Florida Utility Coordination Committee (FUCC) Response to FDOT NexGen Plans, Position Statement

On behalf of the Florida Utilities Coordinating Committee (FUCC), this letter has been drafted to share with the Florida Department of Transportation (FDOT) in writing the concerns about the NexGen plans that have been brought forth by the FUCC membership.

**Summary of Concerns from the
NexGen Plans Non-Standing Subcommittee Meeting Attendees
at the 1/11/2023, 2/8/2023 and 3/8/2023 Meetings**

Exhibit 915-1
Date: 1/1/21

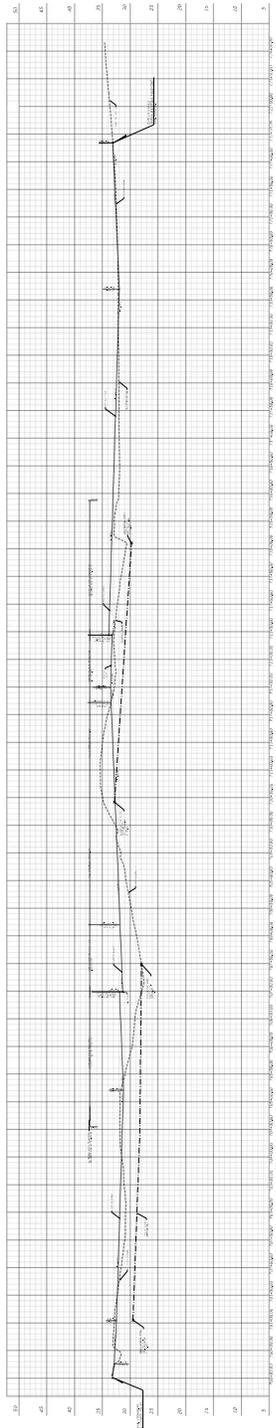
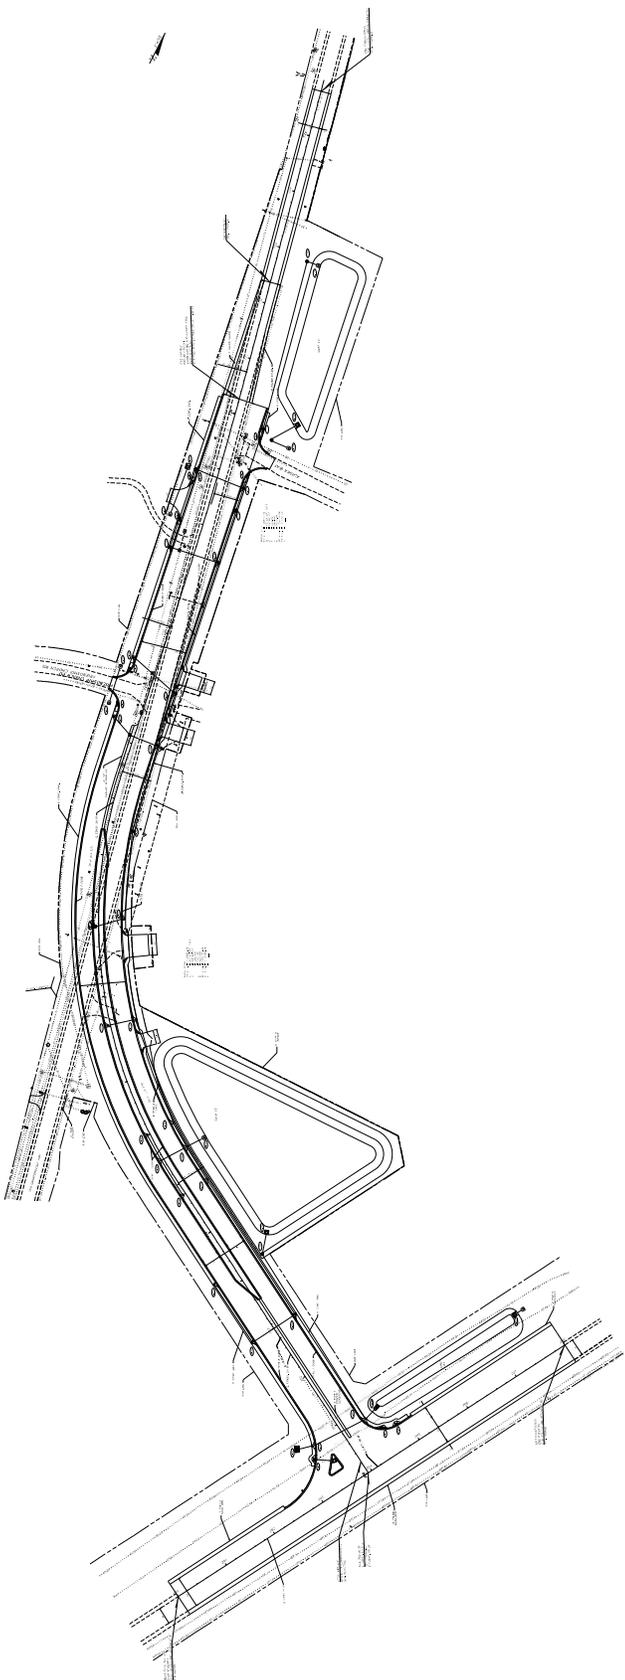
- Need a real-world example of NexGen Plans – physical print (*2)
- Large Format Paper Size – 3 ft by 4 ft, 3 ft by 6 ft
 - Change in plans - margin of error significantly increased. (*1)

- Concern in regard to marking up transmission poles on large format plans is difficult. (*1)
 - 6 ft roll plot is too big for truck and field personnel to use in the field (*2)

- A consultant working for a UAO noted that marking up transmission poles on a 36”x72” roll plot is very difficult. He has seen a few NexGen Plan Sets coming through and he attended today to get more information about what the change was from. He asked what was wrong with the old way and will 11”x17” be sent out still. He noted that this new format creates more room for things to be missed. Ms. Schwartz noted that, as far as the plan size is concerned, it is based on how the project is negotiated. Another UAO attendee noted that at the Fall 2022 FUCC Conference the FDOT Roadway Design advised the FDOT made the changes to the plans. He noted that the utility side of the argument is UAM 5.1.2 states that the “Project drawings are provided to the UAO for mark-up in an agreement format”. He noted that NexGen is not an agreeable format, and this was not a negotiated or agreed upon change – it is a forced change by the FDOT. He noted that when the UAM was developed by rule under the Florida Statute and that is a process where there is public comment and agreement between the FDOT and industry. He advised that his concern is that they never came to industry to discuss this change, never got

Exhibit 923-1
Utility Adjustments
Date: 1/1/2023

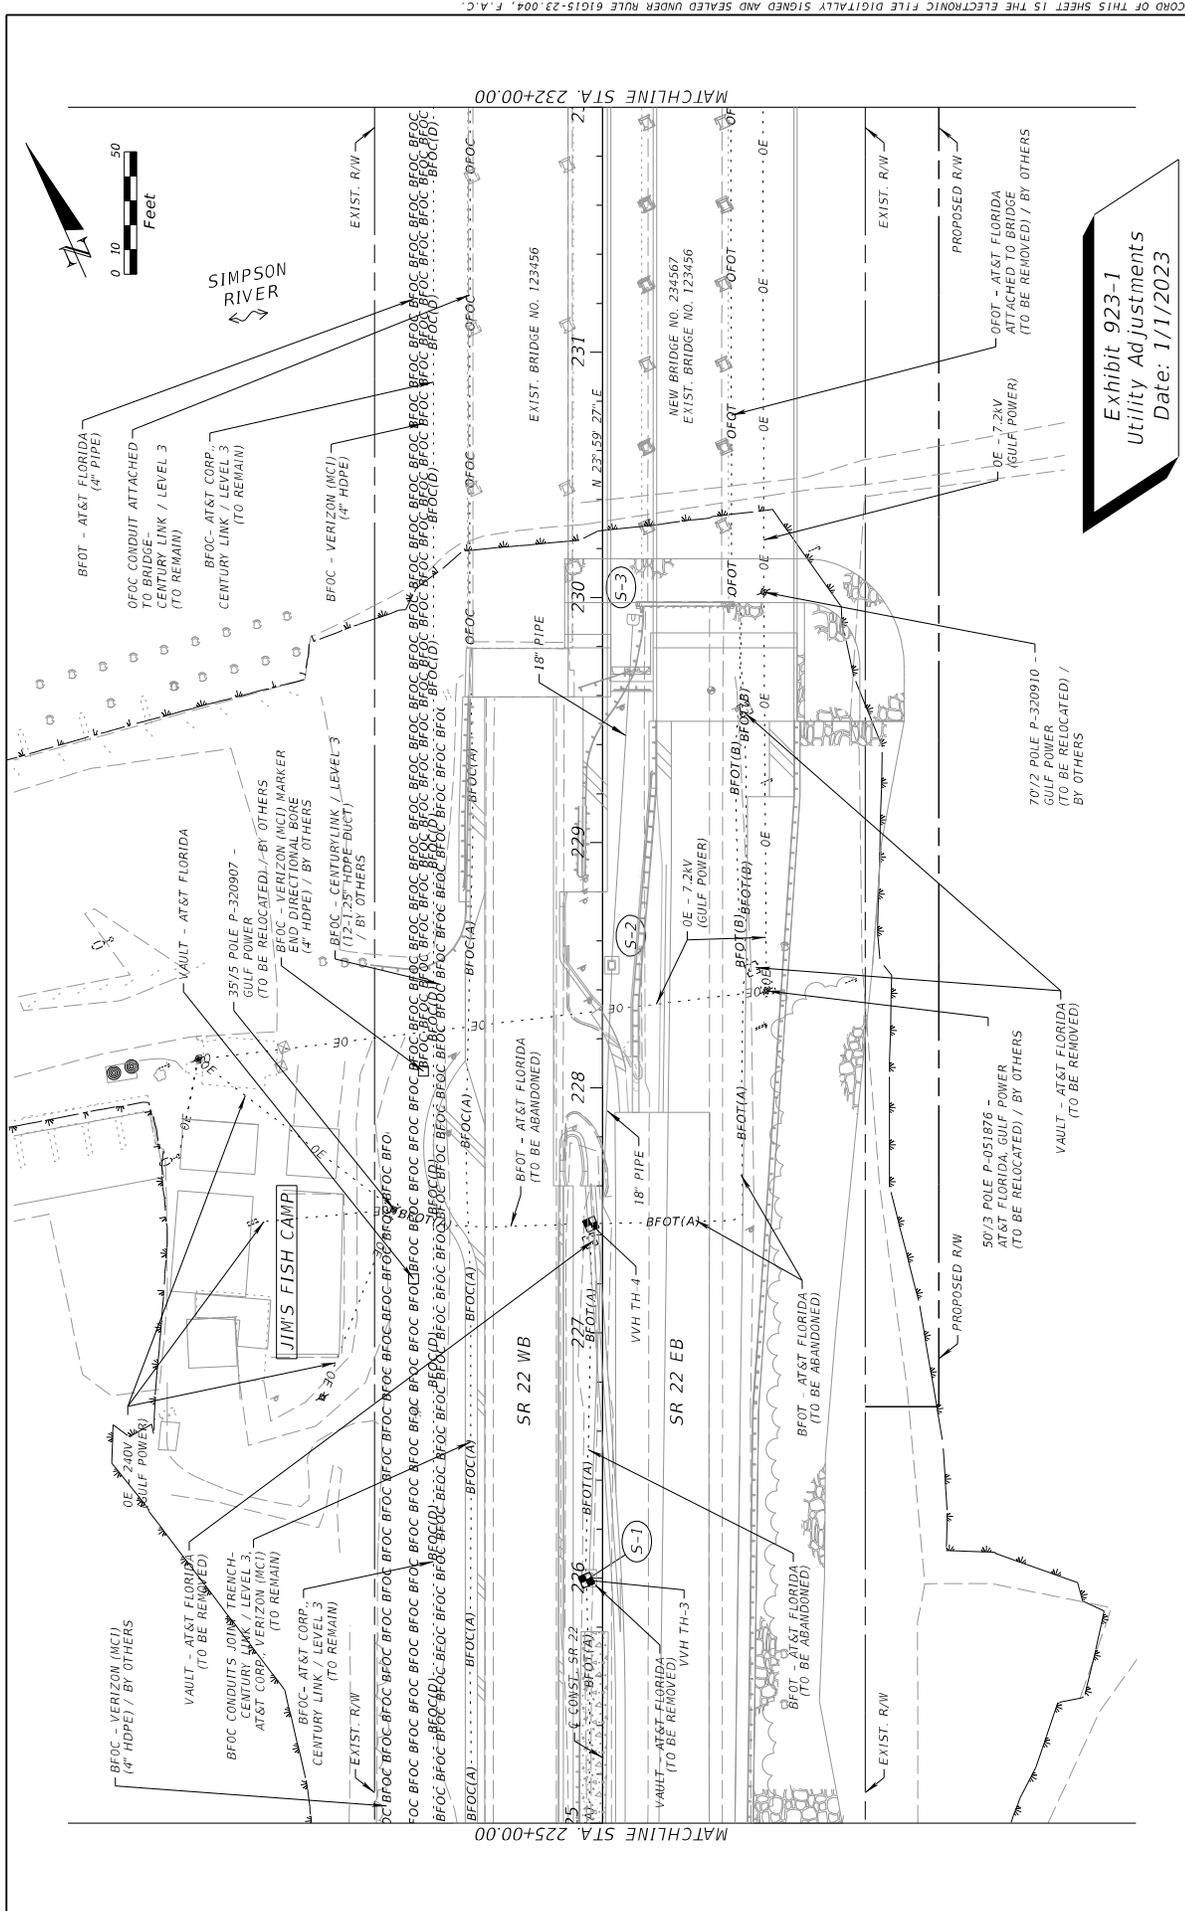
- Utility Work Sheets
 - Labeling issue what the line work represented Existing R/W, Centerlines, north arrow, scales, callouts – concern regarding the higher amount of callouts for the 11x17 utility work sheets (560 ft per sheet) than the large format (2300 ft per sheet) – both from providing a document similar to what has been provided in the past, as well as a level of effort for EOR for units/staff hour concern. Duplicate linework. (*1)

- Ms. Schwartz noted that, as far as the level of effort for the utility work sheets, the concern for effort is the labeling. She advised that with the large format plan sheet you are getting around 2,300 LF on one sheet. She advised that the labeling should be done at a scale for the size of a sheet. Conversely, she noted that on 11”x17” you are getting maybe 500 LF one a sheet. Accordingly, she noted that you would simply need more labels on the 11”x17” to ensure we give enough information on the adjustment sheets.

- A UAO attendee noted that the labels that are missing are actually needed to make them a manageable set of plans. He advised that the utilities need to know that when you chop down the set that is manageable, scalable, has the callouts.
